WILLIAMSON COUNTY, TEXAS

CHANGE ORDER NUMBER: 10

**FM3349 at US 79
Williamson County Project No. 22IFB139**

Change Order No. 10

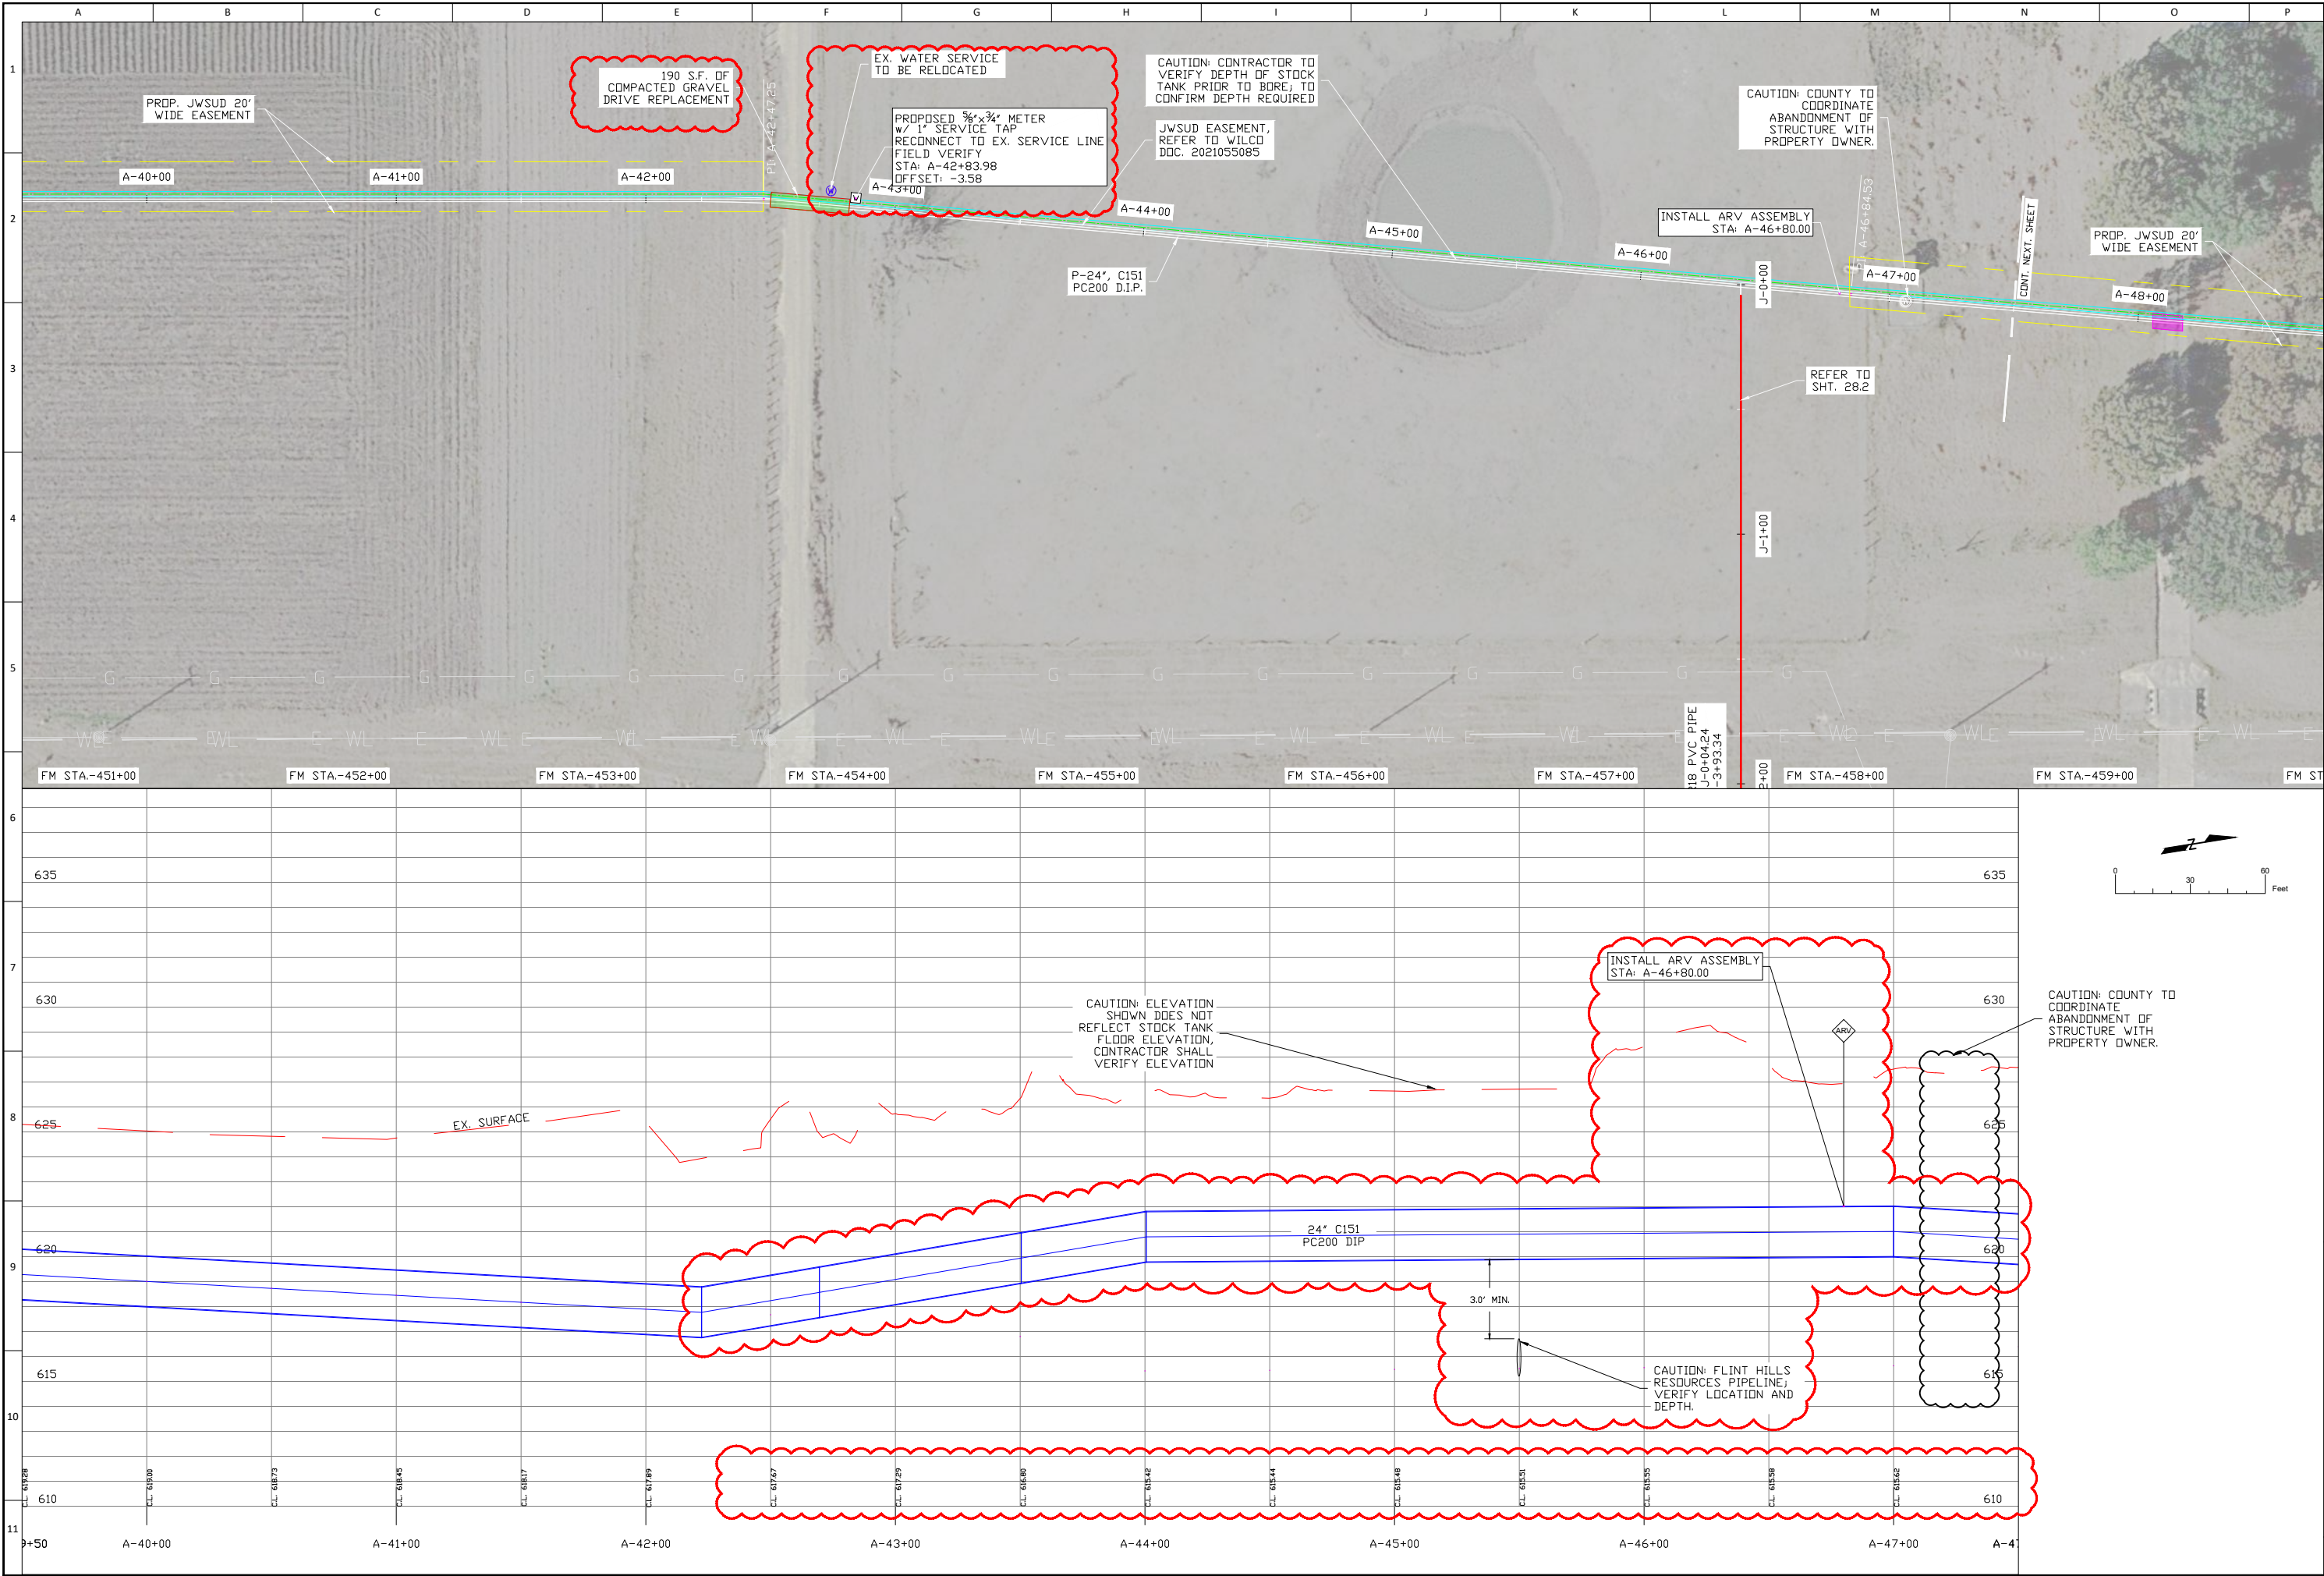
It appears that a water line service from Jonah's proposed 24" DI line to 1280 FM 3349 Taylor Texas was missed. JCG believes that the existing 4" Jonah Waterline services this address. Can EOR confirm that the address mentioned above is serviced by Jonah Water and if it is what is the solution to get this stake holder water service again when the new water line is activated?

The service on the east side of the roadway was missed, please refer to the attached revised sht. 6 and new sht 28.2 to account for this missed water service.

SHEET 6

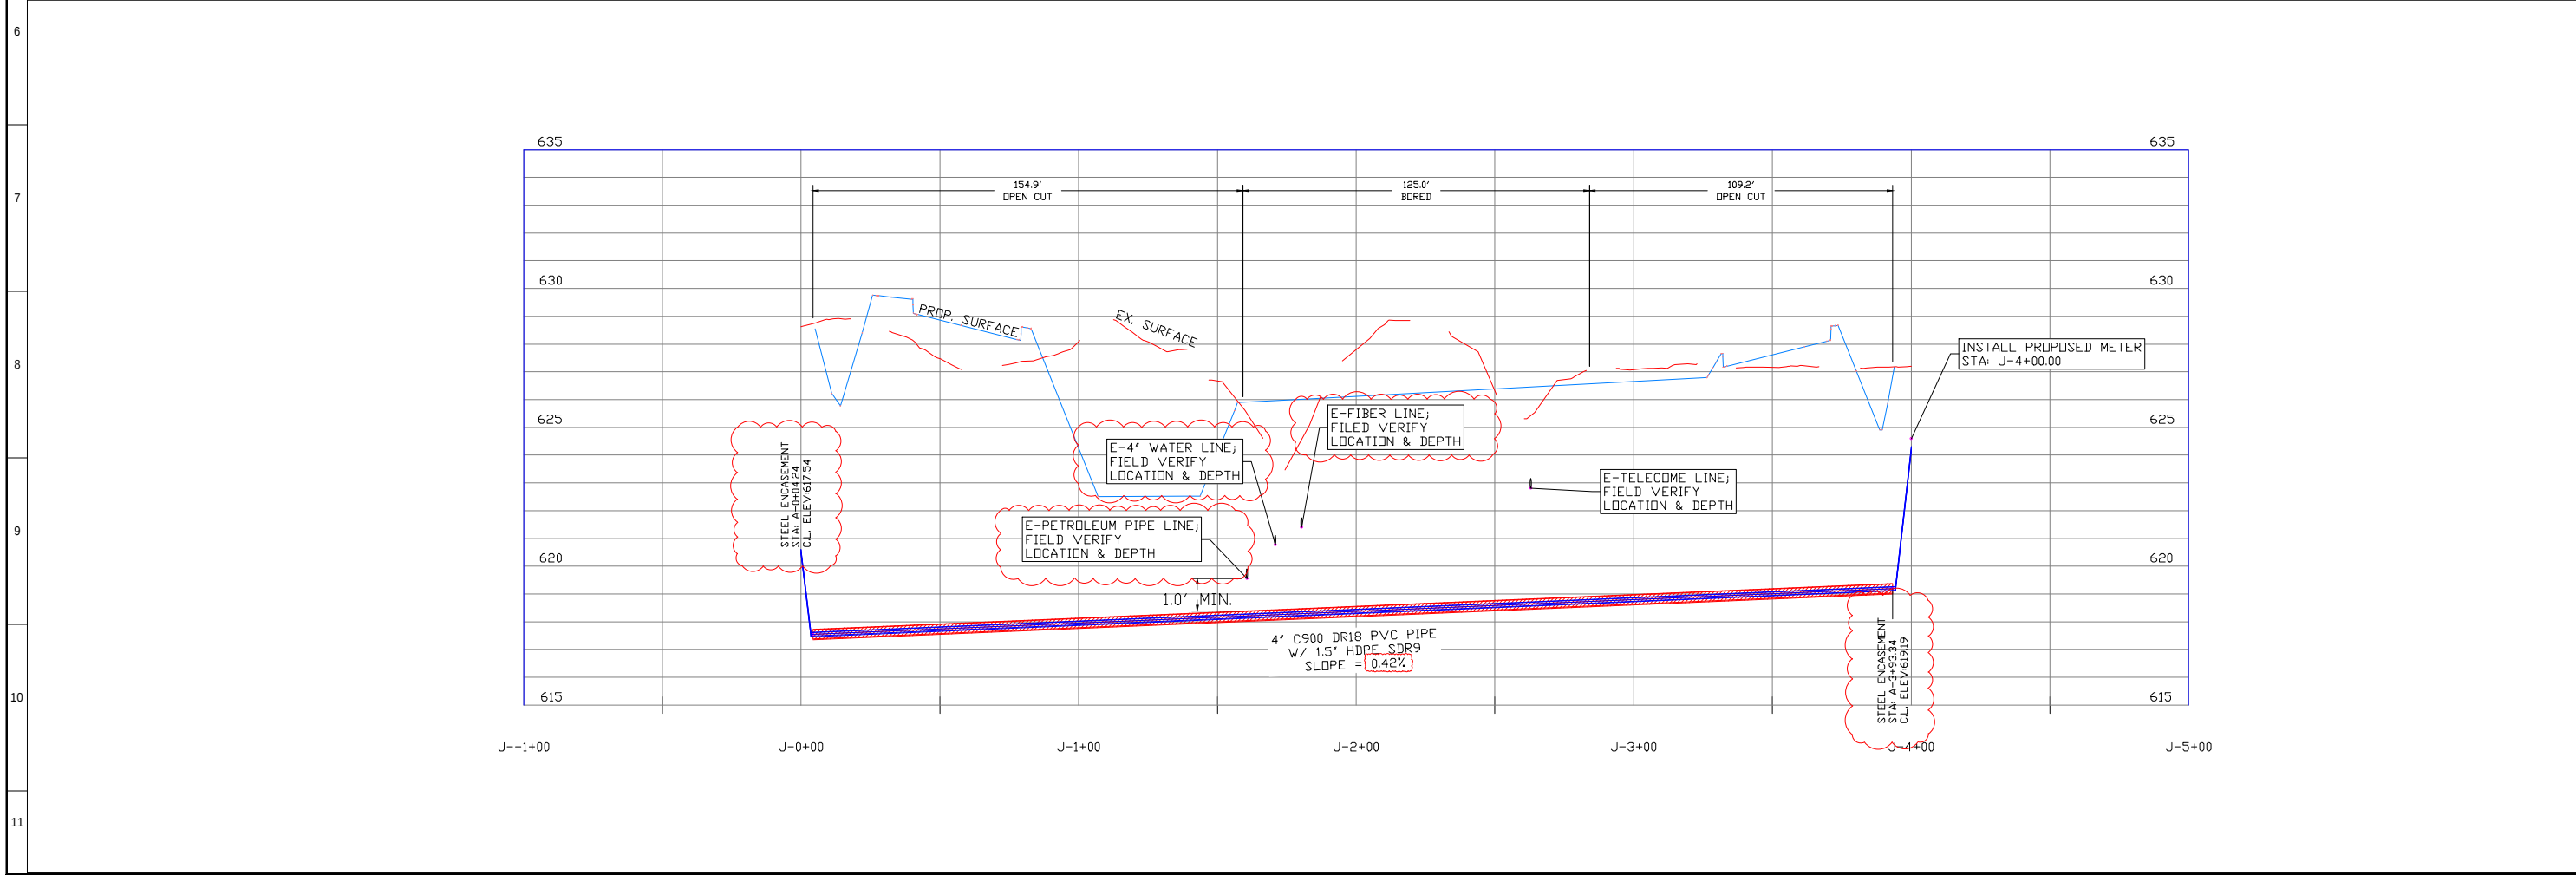
REVISION DESCRIPTION	DATE	BY	CHK
RELOCATE EXISTING WATER METER	3/22/23	MWW	
INCREASE SF OF GRAVEL REPLACE	7/31/23	MWW	
REVISIONS DUE TO FHR OIL PIPELINE	8/15/23	MWW	
ADDED SERVICE STA. 46+39

SHEET 28.2

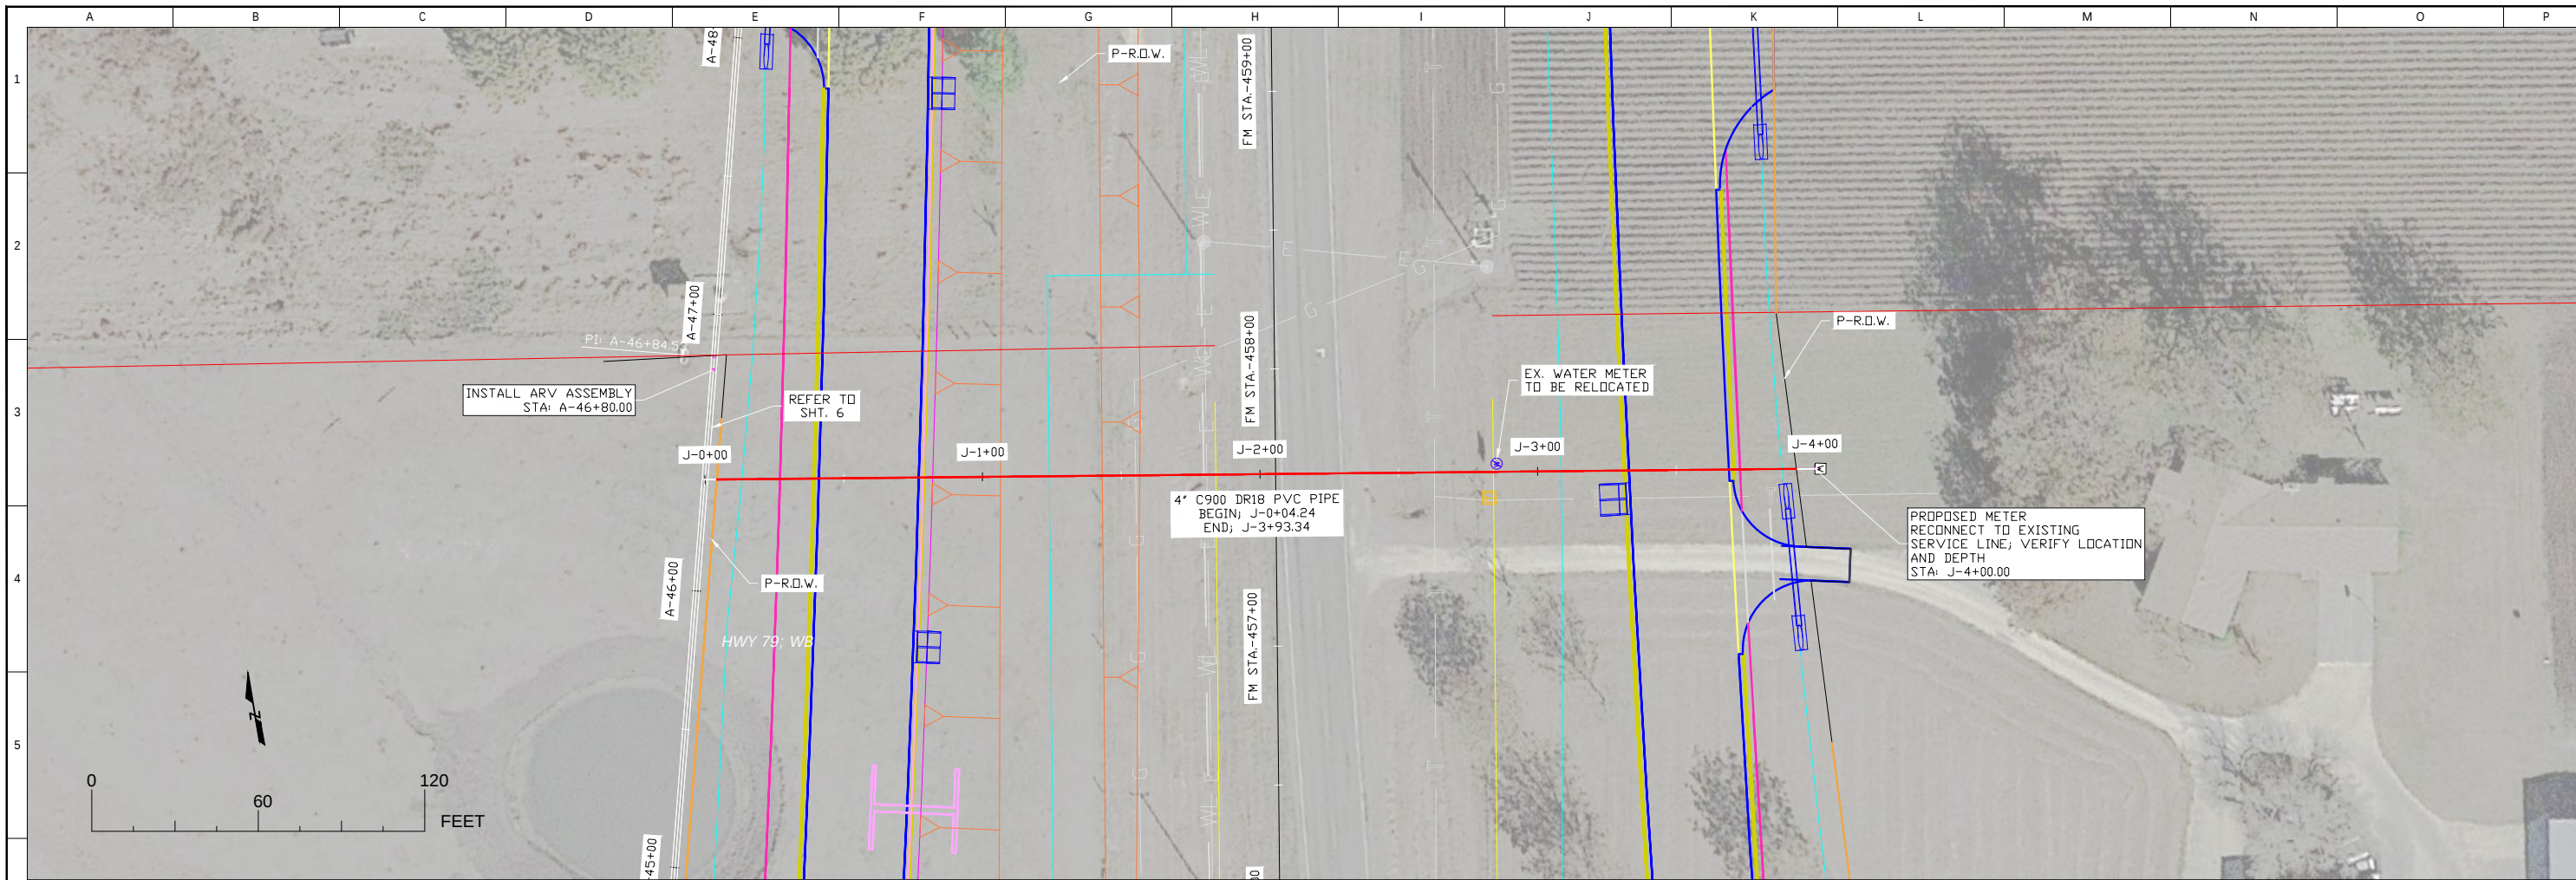
REVISION DESCRIPTION	DATE	BY	CHK
PIPE Elevation & Conflict Locations	10/23/23	JMS	MWW
